SERVICE INSTRUCTION M20-92

**SUBJECT:** REPLACEMENT OF TORSION SPRING IN DRIVE CLUTCH ASSEMBLY OF GEC (PLESSEY) LANDING GEAR ACTUATORS, MOONEY P/N 880037-505 AND 880037-507.

# SERVICE INSTRUCTION

PURPOSE- Replace torsion spring in drive clutch assembly every 1000 flight hours.

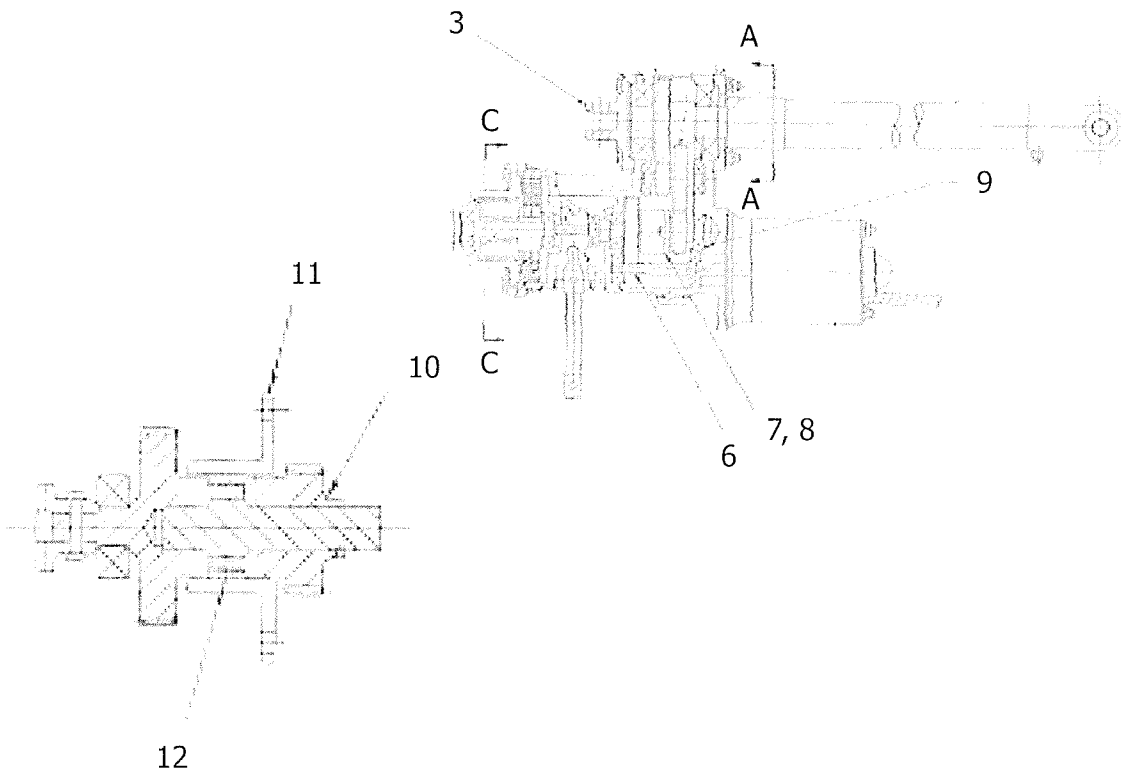
REASON- Two torsion spring failures reported at 1200 and 1500 flight hours.

- 1) Using a razor or sharp knife slice through identification plate.
- 2) Remove eight bolts (1) and eight self-locking nuts (2) from fixed end fitting (3). Discard self-locking nuts.
- 3) Remove fixed end fitting (3). Leave retaining plate on opposite end on screw assembly.
- 4) Remove two bolts (4) and two self-locking nuts (5) that secure housings together. Discard self locking nuts.
- 5) Separate housings and remove pinion (6) with attached bearings.
- 6) Cut lockwire and remove two screws (7) and drive clutch assembly (8) with shims (9).

- 1) Remove spur clutch gear (10), clutch housing (11), and torsion spring (12). Discard torsion spring.
- 2) Clean all removed parts thoroughly.

- 1) Install new torsion spring (12), identified with yellow pinion in ID with tab against stop.
- 2) Re-install clutch housing (11) and spur clutch gear (10).

- 1) Install shims (9) and clutch drive assembly (8) into ball bearing of motor housing. Secure with screws (7). Torque screws 18 to 22 in-lb. Lockwire screw (7) to screw (7).

- 4) Install housings together by lining up ball bearings and slot of drive clutch assembly. Do not use force to join housings.
- 5) Install two bolts (4) and two new self-locking nuts (5) to secure housings together. Torque bolts 60 to 75 in-lb.

- 6) Install fixed end fitting (3) and line up with retaining plate on jackscrew end. Install eight bolts (1) and eight new self-locking nuts (2). Torque bolts 60 to 75 in-lb.
